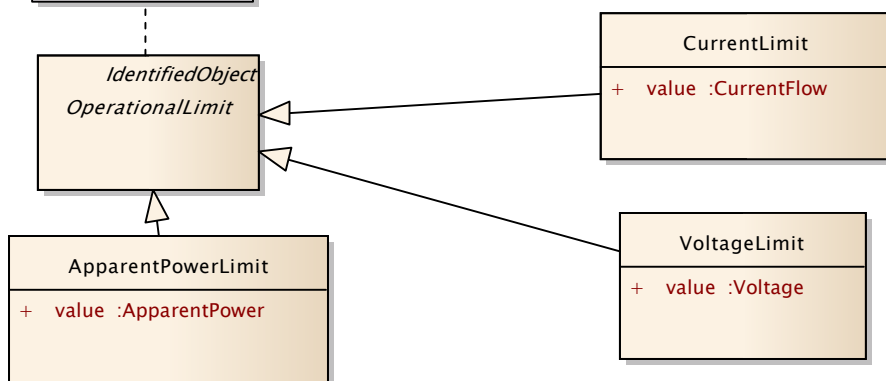
1. Do we need the attribute *.discrete* in the OH profile or it is OK to keep this in the EQ? is it true that discrete/continuous way is depending on the asset? If it like this then it should stay in EQ.
IOP Call reply: *.discrete* in the OH profile

2. Regulating control is now in EQ => should be deleted in EQ as included in the OH profile, but depends on the *.discrete*.
IOP Call reply: some attributes stay in the EQ

3. It is also important to explain how the model works now. If we assume that if EQ is exchanged then all possible "mode" will be present in the EQ then the we do not need *.mode* in OH
IOP Call reply: *.mode* is not changed and it stays in the EQ; it is not in OH

I would put all attributes required. Perhaps only *targetDeadband* could be optional.
 IOP Call reply: all in the OH for *regContr* – required

The 3 classes for limits are now in EQ => they would go to OH i.e deleted from EQ profile

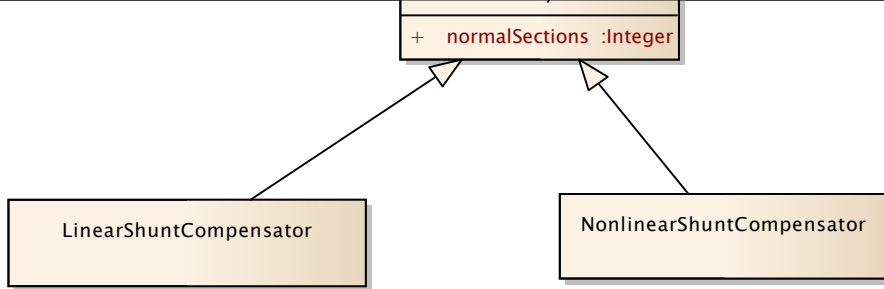
TapChanger.regulationStatus is now optional in EQ profile. I would suggest to delete this in EQ and put it in OH profile as required.
 On the *TapChanger* we are missing position attribute which is now in the *SV* class. How we could deal with this? We could have some attribute *initialPosition* which is the one to be used in the OH profile

- for all shunts normalSections attributes are now required in EQ profile. These could be deleted from the EQ profile and put in the OH profile
- I am not sure if we need something for NonlinearShuntCompensatorPoint and NonlinearShuntCompensatorPhasePoint
- Pay attention that the current SV has only one class SvShuntCompensatorSections has association with ShuntCompensator. Independently from the OH profile discussion do you think we need something in SV ShuntCompensatorPhase

We listed Switch status as a part of the OH profile. Now we have SvStatus in SV profile which is associated with Conducting equipment.

It may be good if the SvStatus idea is put in OH profile as it is not really something coming from the load flow. If we do this are we in fact solving the problem with Switch status and maybe some other equipment status?

ShuntCompensator should have an attribute "actualSections" (actual number of sections in use).

ShuntCompensatorPhase classes are going to be deleted from the transmission profile – 452. Chavdar will change the current EQ

Lars-Ola will make an issue and update UML

We should use Switch.open in the TP profile as required. the description of the attribute may need to be revised
